Access Compliance Report Public Rights-of-Way (Curb Ramps)

Intersection ID: 13037 Main Street: S_CHURCH_ST Cross Street: QUINCEY_ST Location: NW

ADA ID: 338456EE7931 Ramp Type: Perp Initial Pass/Fail: Fail Overall Compliance: No Severity Score: 46.25

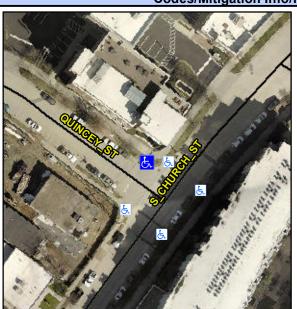
R304.5.1, R304.2.2, R304.5.3

Field Measurements/Component Compliance					
Compliance Description		Data	Compliance Description		Data
N/A	Ramp Length (in)	95.0	No	Ramp Slope (%)	9.5
No	Ramp Width (in)	47.0	No	Ramp XSlope (%)	7.1
N/A	Flare Type LT	N/A	N/A	Flare Type RT	N/A
N/A	Flare Slope LT (%)	N/A	N/A	Flare Slope RT (%)	N/A
N/A	Flare Traversable LT?	N/A	N/A	Flare Traversable RT?	N/A
N/A	Landing Length (in)	N/A	N/A	DWS Provided?	N/A
N/A	Landing Width (in)	N/A	N/A	DWS Contrast?	N/A
N/A	Landing Slope (%)	N/A	N/A	DWS Length (in)	N/A
N/A	Landing X Slope (%)	N/A	N/A	DWS Full Width?	N/A
N/A	Landing Curb? (Y/N)	N/A	N/A	DWS Offset (in)	N/A
N/A	Shared Landing?	N/A			
N/A	Gutter Ponding?	N/A	N/A	Gutter Slope (%)	N/A
N/A	Gutter Lip Ht (in)	N/A	N/A	Gutter X Slope (%)	N/A
N/A	Painted X Walk1?	No	N/A	Painted X Walk2?	N/A
	X Walk 1 Direction	To SW		X Walk 2 Direction	N/A
N/A	X Walk 1 Width (in)	N/A	N/A	X Walk 2 Width (in)	N/A
	X Walk 1 Slope (%)	1.5		X Walk 2 Slope (%)	N/A

Remove & Replace Entire Ramp.
